Kenpark Bangladesh (Pvt) Ltd. (Extension)

Plot # 31-42, Sector # 08, Chittagong EPZ, Chittagong.

13 December 2023

2. Observations

Observation-2: Incomplete as-built drawing (Canteen building and rain protection shed)

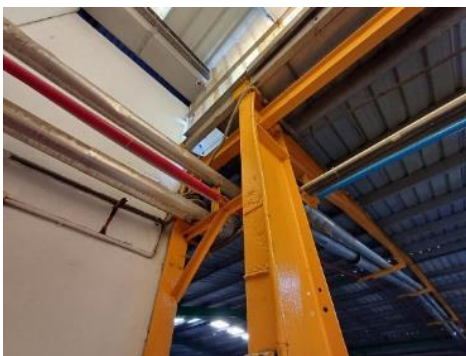
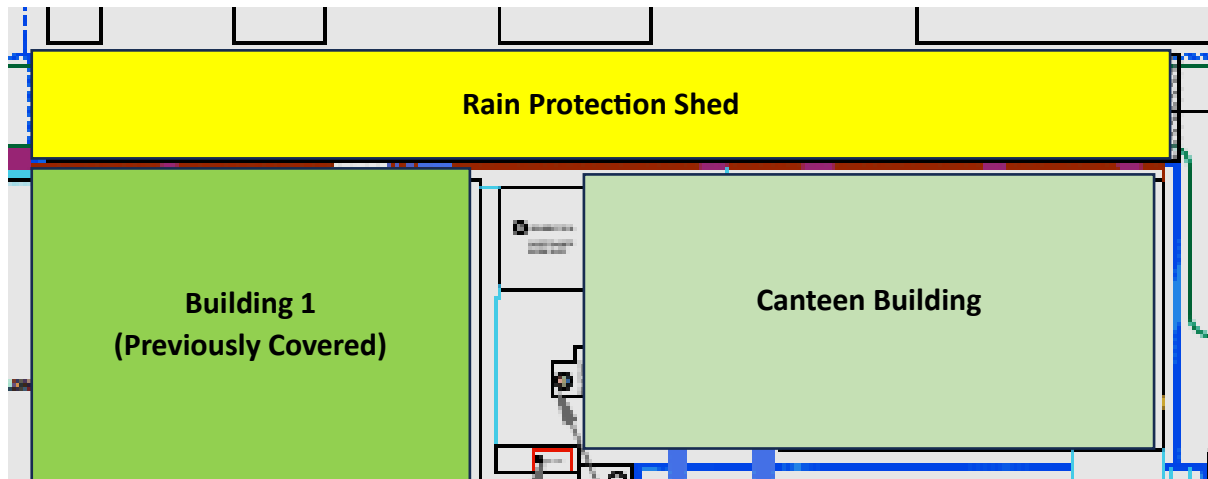
Description: Flange thickness of steel column for Rain Protection Shed was found 7.1 mm instead of 8 mm. Also, the flange thickness of several columns and rafters of Canteen Building were found 5 to 8 mm instead of 10 mm. Details of compression strut, roof bracing, connection was not found in as-built drawing. Building engineer is required to survey whole structure and prepare accurate as-built drawings as per site condition.

Observation-3: Lack of lateral stability (Canteen building and Rain protection shed)

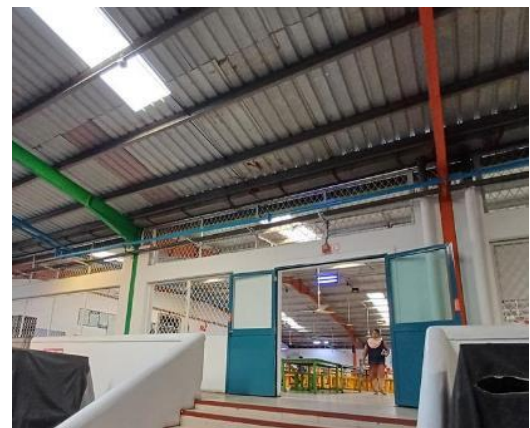
Description: Rain Protection Shed is partially connected with Canteen Building and partially connected with Building 1. Besides, no compression strut at ridgeline and vertical bracing in north-south direction. Building engineer is required to check the stability system & adequacy of all structural element, connection etc. and submit to RSC for review.

Observation-4: High stress in Column and Footing (3D Building).

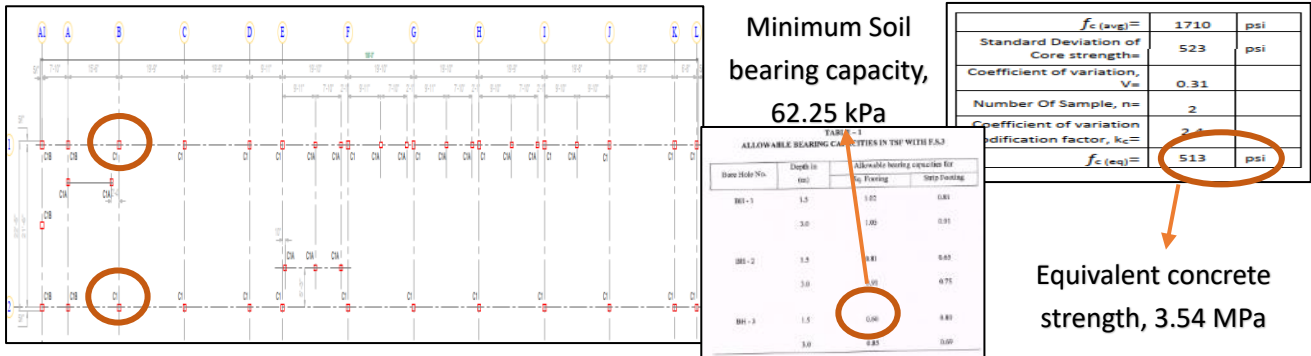
Description: Cursors calculation indicates high stress in the marked columns and footings based on live load (3kPa for typical floor, 1.5 kPa for Roof), dead load (including wall load) and 62.25 kPa for foundation capacity & 3.54 Mpa concrete strength for column as per core test report. The source of loading is minimum live load as per load plan and partition wall. The building engineer is required to carry out Detail Engineering Assessment (DEA) to review the design, loads, column capacity and foundation stress based on in-situ material strength, and minimum floor live loads.

Observation-5: Remediation works needs to be completed (3D Building).

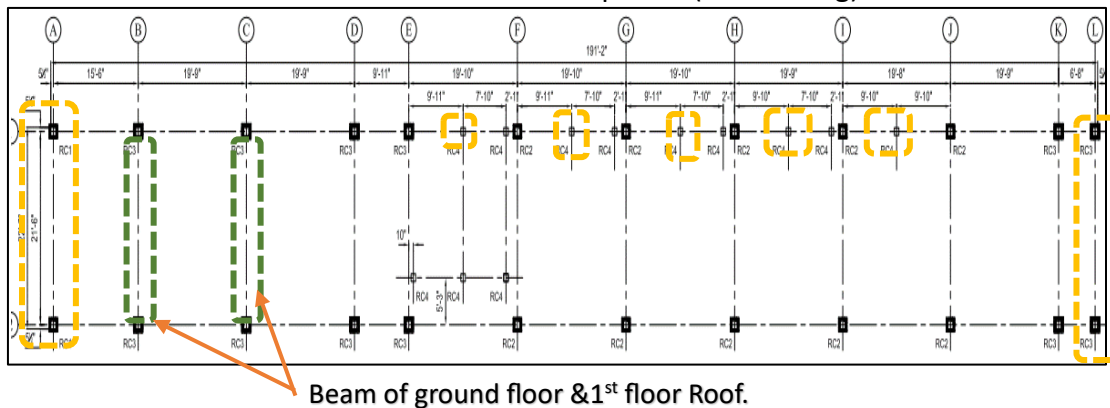
Description: Marked columns and beam were required to retrofit as per retrofitting drawing. However, during inspection remediation works were found incomplete for these columns and beam. Factory is required to complete the remediation works as per retrofitting drawing.

Observation-6: Mismatch in as built drawings (3D Building).

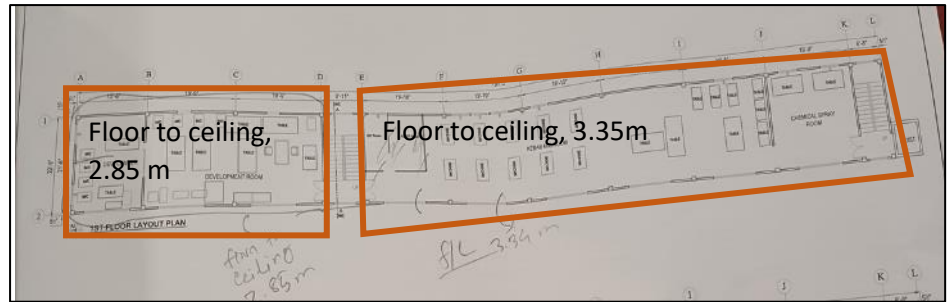
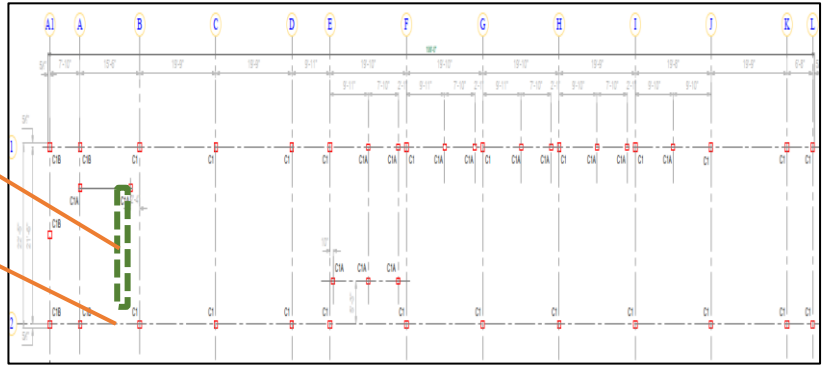
This Beam & Column not shown in drawings.

Different level was observed between these two parts at 1st floor level.

Description: During inspection, mismatches were found between onsite condition and as-built drawing. Some column and beam are not shown up to 1st floor roof. Also, different floor to ceiling height was observed on 1st floor level. The building engineer is required to survey the full structure and produce accurate as-built drawings.

Observation 7: Mismatches in as built drawings (Prayer & locker building)

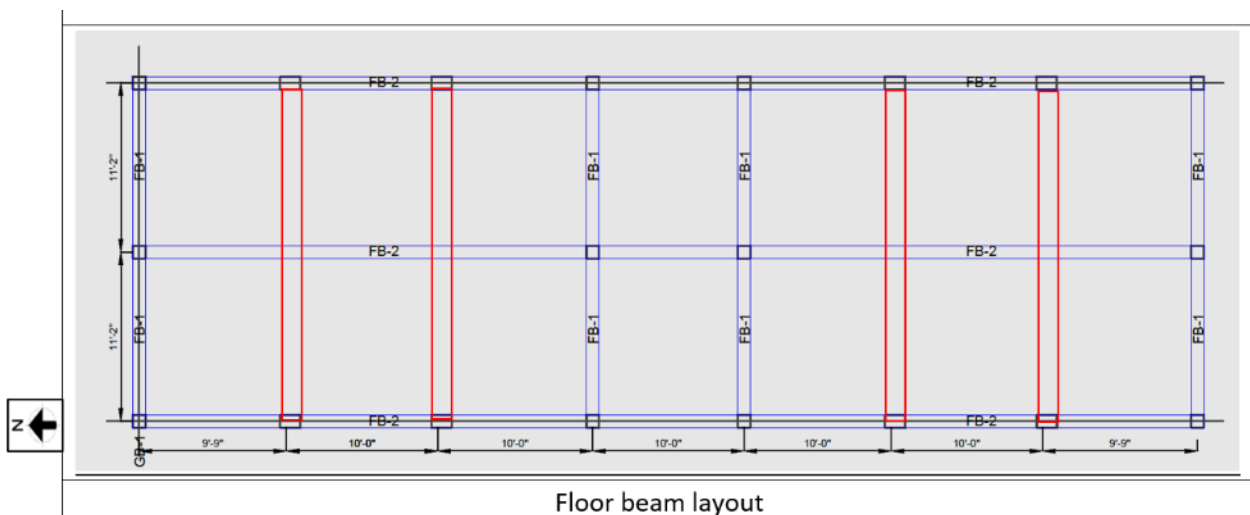
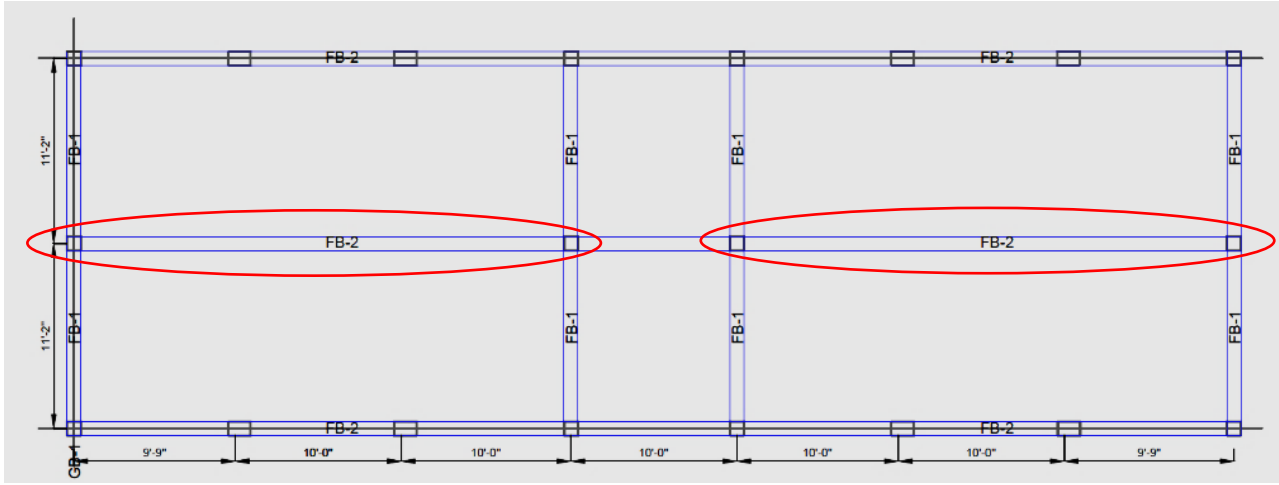
Description: Red marked beams were found onsite but not shown in drawing.

Description: Marked beams were not found onsite. Moreover, foundation and slab details are not shown in as-built drawings.

Building engineer is required to update the as-built drawing.

Observation 9: Crack on beams (Compressor Room 1)

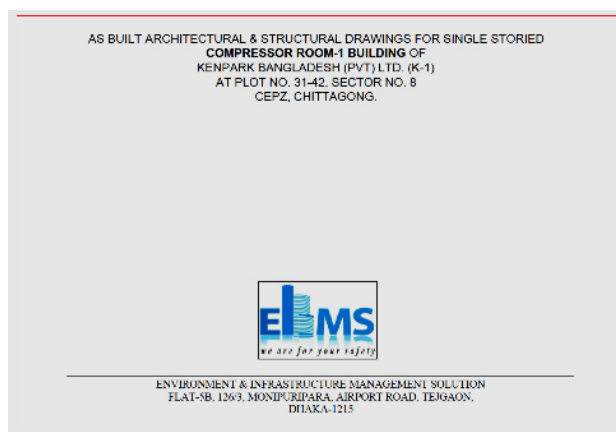
Description: Crack was observed on beam surface. The building engineer is required to check the extent of crack and prepare an investigation report with necessary remedial measure.

Observation 10: Lack of information in as built drawings. (Compressor room 1)

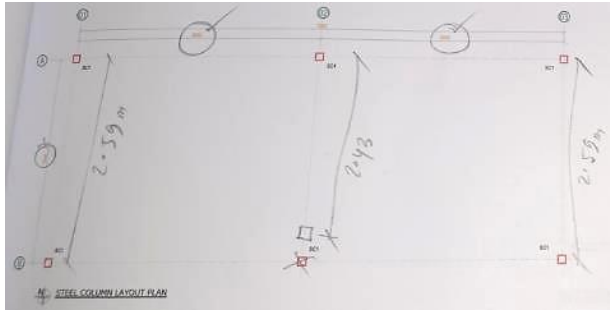
Description: During the inspection, the factory provided a set of as-built drawing. But foundation and slab details are not shown in as-built drawings. The building engineer is required to update the as-built drawing.

Observation 11: Discrepancies in as-built drawing (CMS Shed)

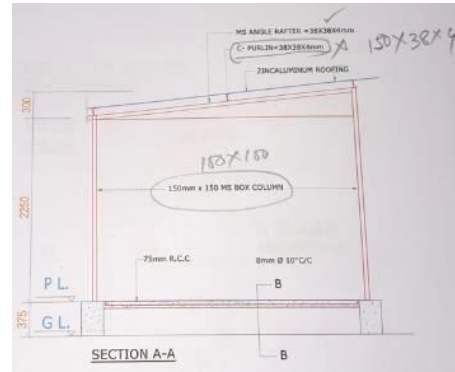
Description: On-site grid spacing, and location of column did not match with as-built drawing. Also, steel column size found 100X100 box section instead of 150X150 box and C-channel found 150X38X4 instead of 38X38X4. The building engineer is required to survey the whole structure and revise the as-built drawing as per actual site condition.

Observation-17: Lack of lateral stability (RWTP Shed - 2)

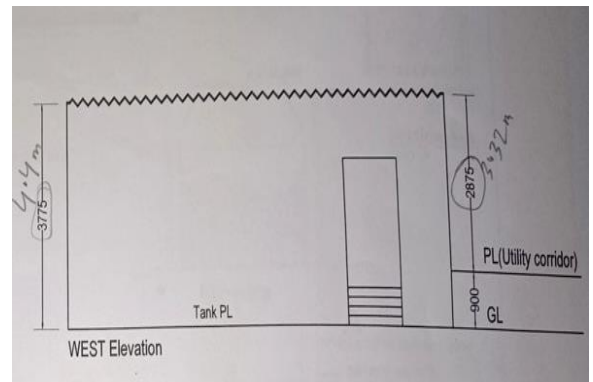
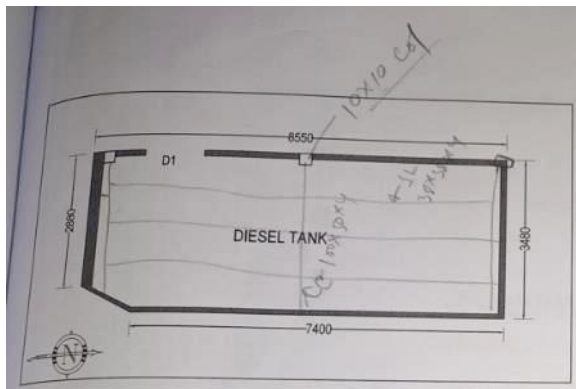
Description: Lack of lateral stability system, apparently inadequate members and non-engineered connection were observed. The building engineer is required to check the member, connection & stability system of the structure and suggest proper remediation accordingly.

Observation 18: Lack of as-built drawing (Diesel tank shed)

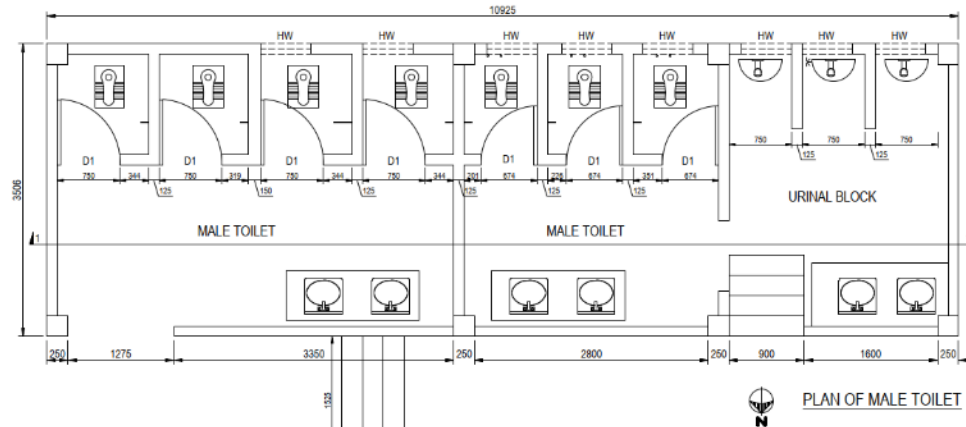
Steel member, Column and Foundation details not available

Description: Details of steel members, columns and foundations were not available, only architectural plan was available. The building engineer is required to prepare a complete set of drawings as per actual site condition.

Observation 19: Lack of As-built drawing (Male toilet block)

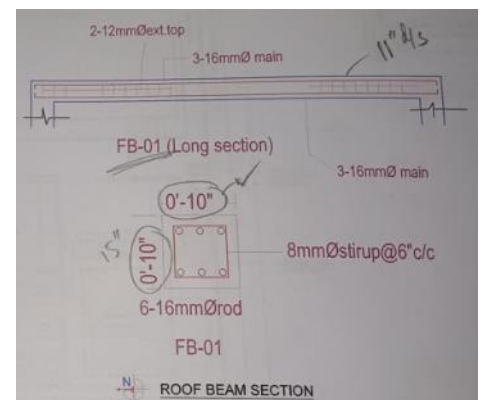
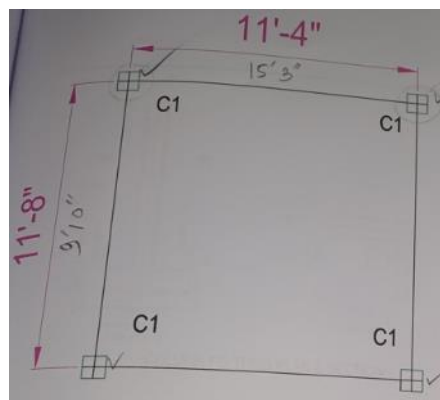
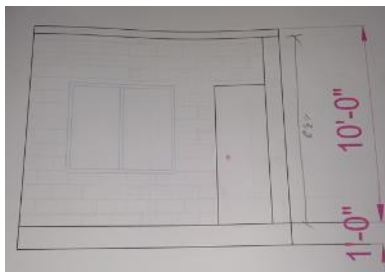
Beam, Column and Foundation details not available

Description: Details of beams, Columns and Foundations were not available, only an architectural plan was available. The building engineer is required to prepare a complete set of as-built drawings as per actual site condition.

Observation 20: Discrepancies in As-built drawing (Driver's waiting room)

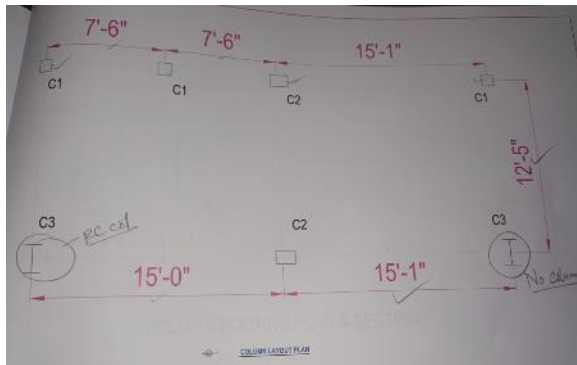
Description: On-site grid spacing, height, beam section did not match with as-built drawing. A details were not available. The building engineer is required to survey the whole structure and re as-built drawing as per actual site condition.

Observation 21: Discrepancies in As-built drawing (Chemical issue room)

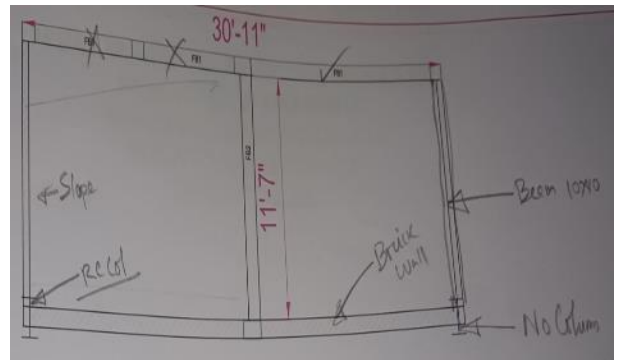
Mismatch in Column

Beam Layout not matched

Description: Column layout and beam layout did not match with as-built drawing. The building engineer is required to survey the whole structure and revise the as-built drawing as per actual site condition.

Observation 23: Structurally connected with 3D Building (WP QC area shed)

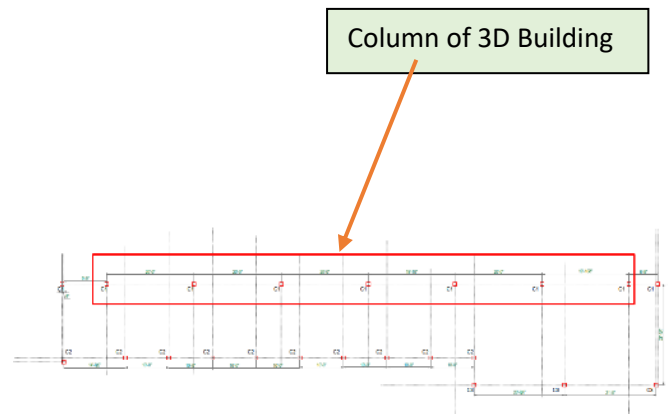
Description: Columns of this structure found connected with 3D Building. The building engineer is required to analysis the structure with 3D building otherwise separate the structure.

Observation 24: Discrepancies in As-built drawing (WP QC area shed)

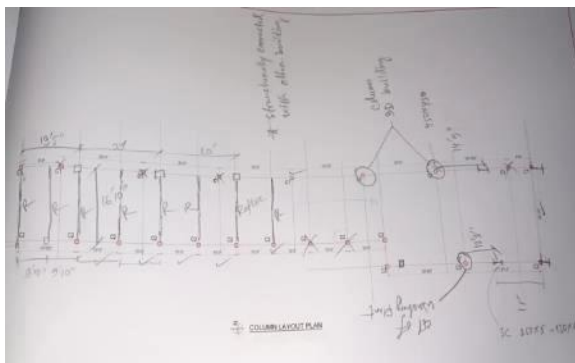
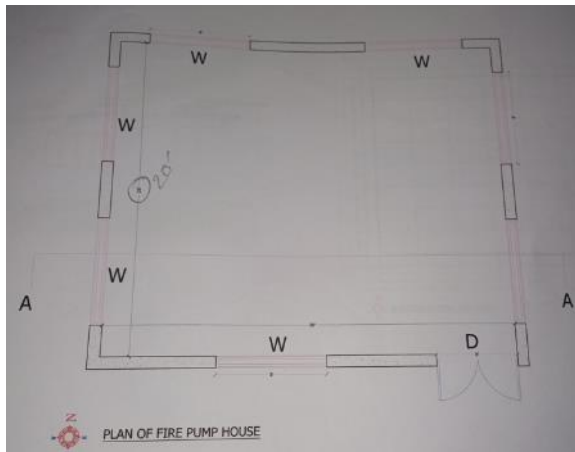
Description: Column layout and Rafter layout in as-built drawing did not match with actual site condition. The building engineer is required to survey the whole structure and revise the as-built drawing as per actual site condition.

Observation 25: Discrepancies in As-built drawing (Fire pump room)

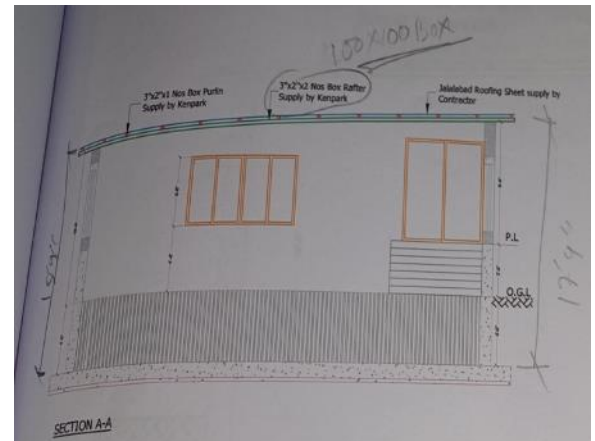
Description: On-site grid spacing did not match with as-built drawing. Also, steel column size found 100X100 box section instead of 75X50 box. The building engineer is required to survey the whole structure and revise the as-built drawing as per actual site condition.
